# Access Compliance Report

## Public Rights-of-Way

Intersection ID: 50602	Main Street: RHODORA_RD	Cross Street: CEDARFIELD_RD	Location: SW
ADA ID: 7AD2BF9744B2	Ramp Type: Perp	Initial Pass/Fail: Fail	Overall Compliance: No
Severity Score: 35			
Codes/Mitigation Info/Possible Solution		Field Measurements/Component Compliance

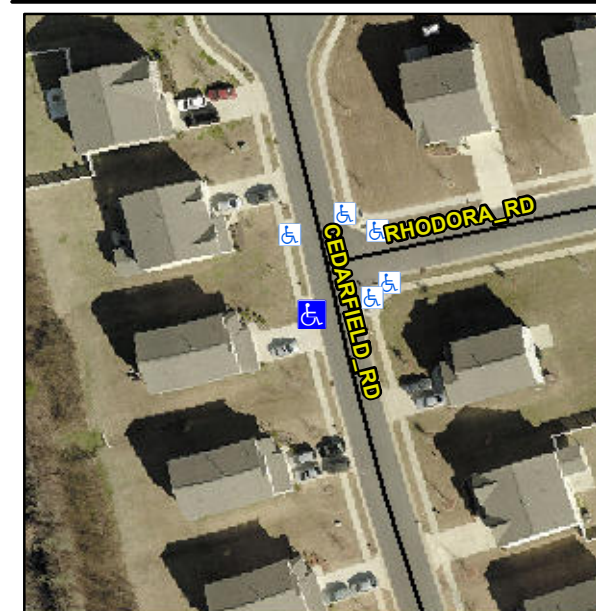
**Not Found, R304.5.1, R304.2.2**

Compliance	Description	Data	Compliance	Description	Data
N/A	Ramp Length (in)	47.5	No	Ramp Slope (%)	14.4
No	Ramp Width (in)	47.0	Yes	Ramp XSlope (%)	3.2
N/A	Flare Type LT	N/A	N/A	Flare Type RT	N/A
N/A	Flare Slope LT (%)	N/A	N/A	Flare Slope RT (%)	N/A
N/A	Flare Traversable LT?	N/A	N/A	Flare Traversable RT?	N/A
N/A	Landing Length (in)	N/A	N/A	DWS Provided?	N/A
N/A	Landing Width (in)	N/A	N/A	DWS Contrast?	N/A
N/A	Landing Slope (%)	N/A	N/A	DWS Length (in)	N/A
N/A	Landing X Slope (%)	N/A	N/A	DWS Full Width?	N/A
N/A	Landing Curb? (Y/N)	N/A	N/A	DWS Offset (in)	N/A
N/A	Shared Landing?	N/A			
N/A	Gutter Ponding?	N/A	N/A	Gutter Slope (%)	N/A
N/A	Gutter Lip Ht (in)	N/A	N/A	Gutter X Slope (%)	N/A
N/A	Painted X Walk1?	No	N/A	Painted X Walk2?	N/A
	X Walk 1 Direction	To E		X Walk 2 Direction	N/A
N/A	X Walk 1 Width (in)	N/A	N/A	X Walk 2 Width (in)	N/A
	X Walk 1 Slope (%)	1.8		X Walk 2 Slope (%)	N/A
	X Walk 1 X Slope (%)	3.5		X Walk 2 X Slope (%)	N/A

**Remove & Replace Entire Ramp.**
